**Item #2:**  
**Report Of May 4, 2011 CSCC Meeting**  
**Trails End Subdivision, Pickell**

**TO:** CSCC CHAIR SMITH AND COMMITTEE MEMBERS  
**FROM:** JAMES M. HOGUE, VILLAGE PLANNER  
**DATE:** April 27, 2011  
**RE:** May 4, 2011 - MEETING ISSUE REVIEW

**CSCC #11-04 – Consideration of the final plat of subdivision of property to be known as the “Trails End Estates” Subdivision and within the R-2 Residential District, including the location of Conservancy District Boundaries, on property commonly known as 1889 Checker Road submitted by Orrin Pickell Designers & Builders.**

# FINAL PLAT OF 1889 CHECKER ROAD SUBDIVISION

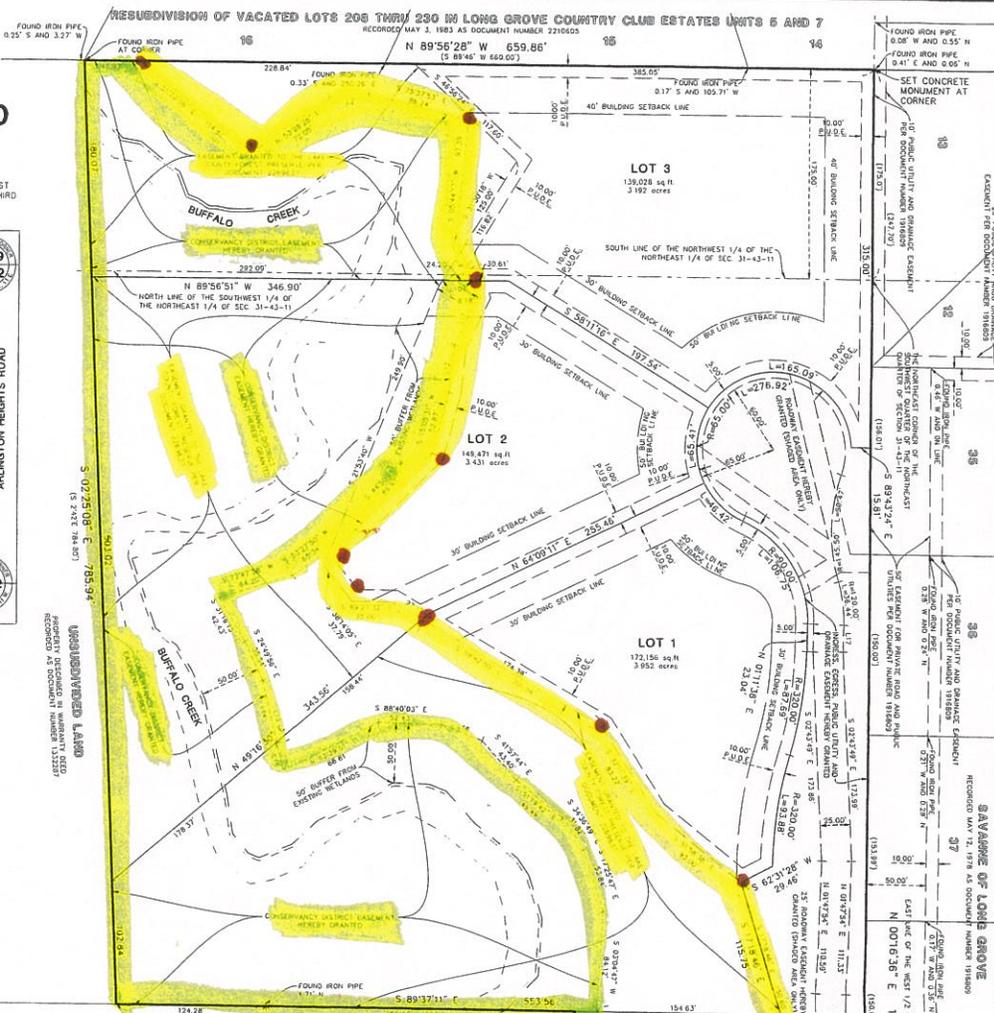
A small "finger" (.10 acres) of conservancy soil (Type 153 A) extends into the proposed Lot 1 of the three lot development. The petitioner is requesting this area be removed from consideration as a part of the conservancy district designation within this development.

Staff finds this request consisted with current policy regarding the establishment of conservancy districts and which has been implemented in most of recent developments within the community.
